### Permit of Authorization to Construct an On-Site Sewage Facility Permit Valid For One Year From Date Issued

### REVISED 8:06 am, Dec 01, 2023

#### **OSSF DESIGN**

#### AS-BUILT DESIGN:

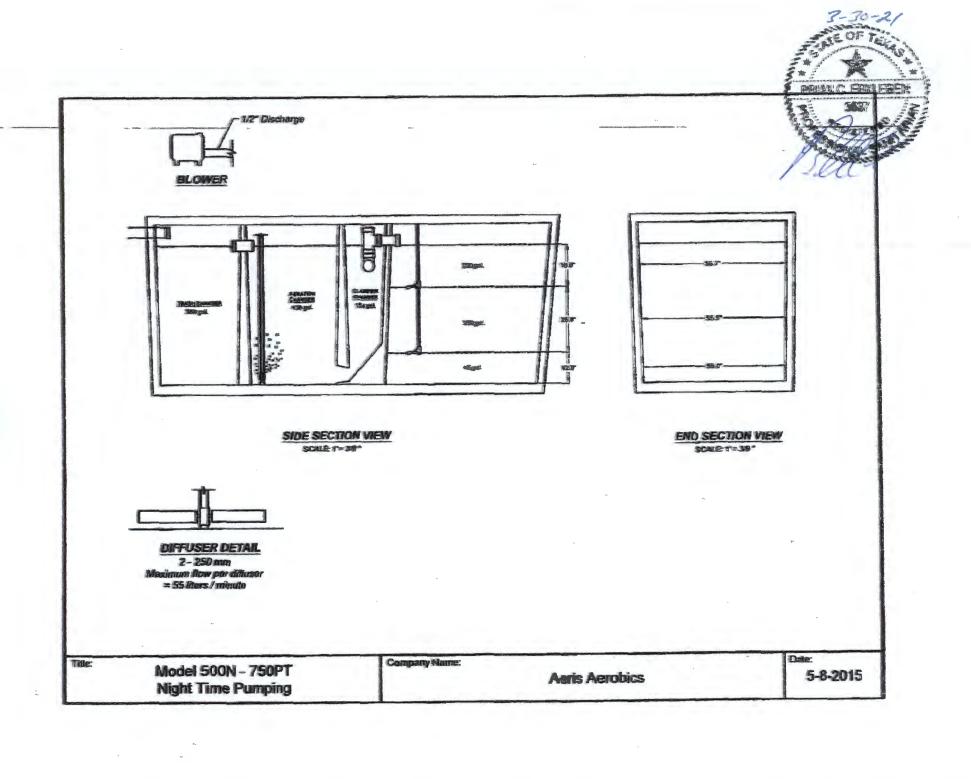
This is a revision changing the MH to a residence. Home location changed slightly. Crystal, you and Carlos need to sign the bottom of the revised application and then send it to Brenda please.

Development: Residence with water saving devices Bedrooms: 3 Sq. Ft: 1500

- 4. S1-3 are K-Rain Proplus low angle sprinklers with #3 nozzles operating @ 30 psi, 180° pattern, 29' radius. Adequate space is not available to provide a 20' setback between the spray area and the property line. A variance is requested to locate the spray area 10' from the property line. A battery backup shall be installed in the control panel to insure that the timer does not lose power and that the system sprays only between the hours of 12:00 AM & 5:00 AM providing the equivalent protection of a 20' separation between the spray area and the property line.
